Technical Letter Report
on
PNNL Review of Farley Unit 1
1995 Interim Plugging Criteria 90 Day Report

Prepared for
Office of Reactor Regulation
U.S. Nuclear Regulatory Commission
under Contract DE-AC06-76RL0 1830
NRC JCN E2029

Pacific Northwest National Laboratory
Richland, Washington 99352

Figure 1: Distributions of projected EOC 14 voltages.

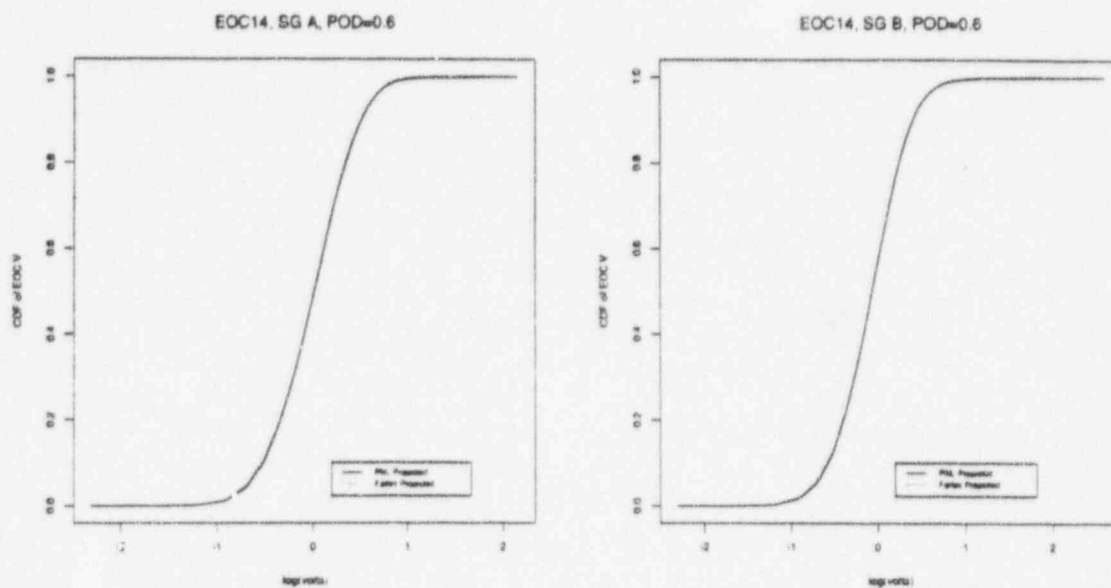
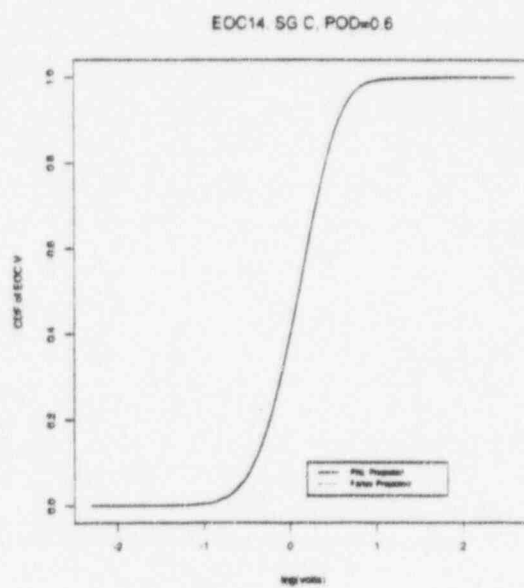
These inputs were used to calculate the projected EOC 14 bobbin voltage distributions given in Table 7-2 in [1]. PNNL's corresponding projections plotted against the Farley Unit 1 projections are presented in Figure 1 and Table 1. As can be seen from the results, Farley Unit 1 calculations agree very closely with PNNL's.

Figure 2: Comparison of Projected and Actual EOC 13 Voltage Distributions

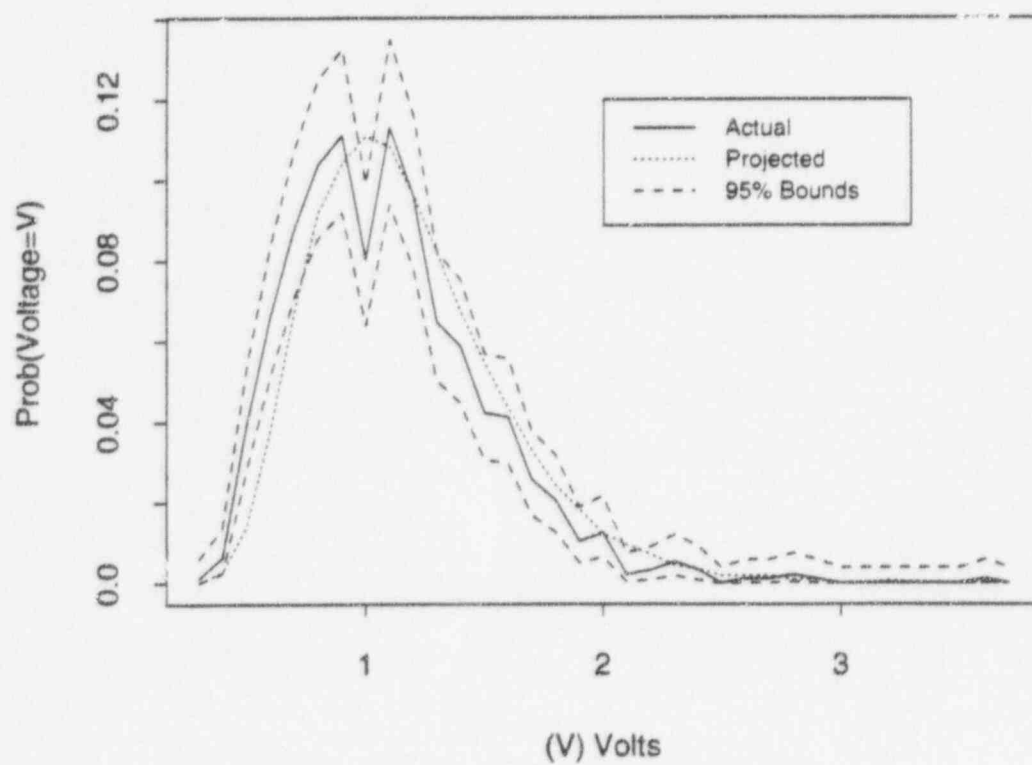
This submittal also compared the projected EOC distribution with the observed distribution for EOC 13. Figure 2 presents a comparison of the projected with actual EOC 13 Voltage distribution. The actual distribution in this plot has been surrounded by 95% confidence bounds, which describe the amount of variability one would expect in an estimate such as this when it is being estimated from a sample of this size. These particular confidence bounds

do not describe the sizing and detection inspection errors that might be present within the actual distribution. Nevertheless, the confidence bounds give a gauge that can be used to compare the two distributions.

As one can see from the Figure, the projected distribution generally falls within the 95% bounds, indicating agreement between the projected and actual distributions. These results show that the strategy of using the voltage growth rates from the previous cycle gives a good prediction for the next cycle.
